Massachusetts Department of Transportation, Highway Division

SUPPLEMENTAL SPECIFICATIONS

1988 English Standard Specifications for Highways and Bridges

FEBRUARY 25, 2010

FIGURE 1

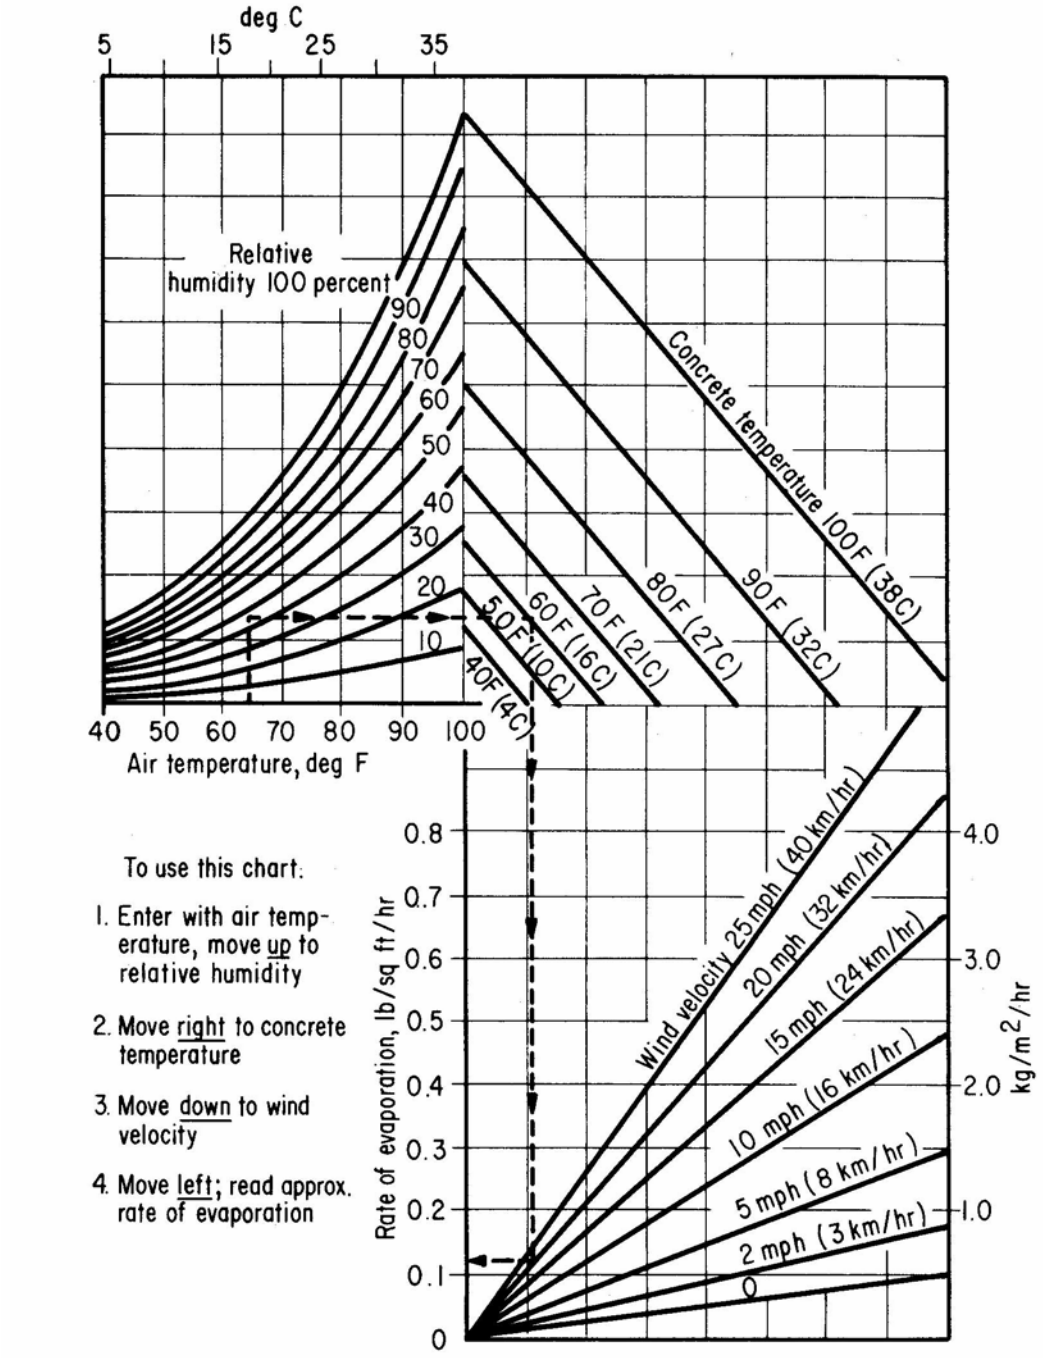
The weight of the finishing machine(s) shall not cause unaccounted deflection of the bridge members or falsework. The machine shall travel on steel rails, pipe or other approved grade control, which shall be supported by vertical supports securely fastened in place at a maximum spacing of 2 feet (200 mm) to prevent any appreciable deflection between rail supports. Screed rail supports may be located inside or outside of the placement width. Prior to placing the concrete, screed rails shall be completely in place, and accurately set to insure finishing of the concrete deck surface to the elevations shown on the Plans. The supports for the rails, if embedded in the deck concrete, shall be of the type that can be removed without disturbing the concrete.

Screed rails shall be set entirely above the finished surface of the concrete and shall be supported in a manner approved by the Engineer. Where stud type shear connectors are available, welding to the studs will be permitted. Where no studs are available, other means of attaching the screed rail supports shall be provided. No welding will be permitted directly on stringer or girder flanges or cover plates in tension areas, nor in areas subject to stress reversal, for attaching either screed rail supports of any type. Any welding in compression areas shall be approved by the Engineer.

Screed rail supports set in the concrete shall be so designed that they may be removed to at least 2 inches (50 mm) below the surface of the concrete. Voids created by removal of the upper part of the screed rail supports shall be filled with mortar having the same proportions of sand and cement as that of the slab or wearing surface. The mortar shall contain an approved additive in sufficient proportions to produce non-shrink or slightly expansive characteristics. Screed rail supports shall not be treated with parting compound to facilitate their removal. Rails for finishing machines shall extend beyond both ends of the scheduled length for concrete placement. The extended length shall be of sufficient distance to allow finishing machine(s) to clear the concrete to be placed.
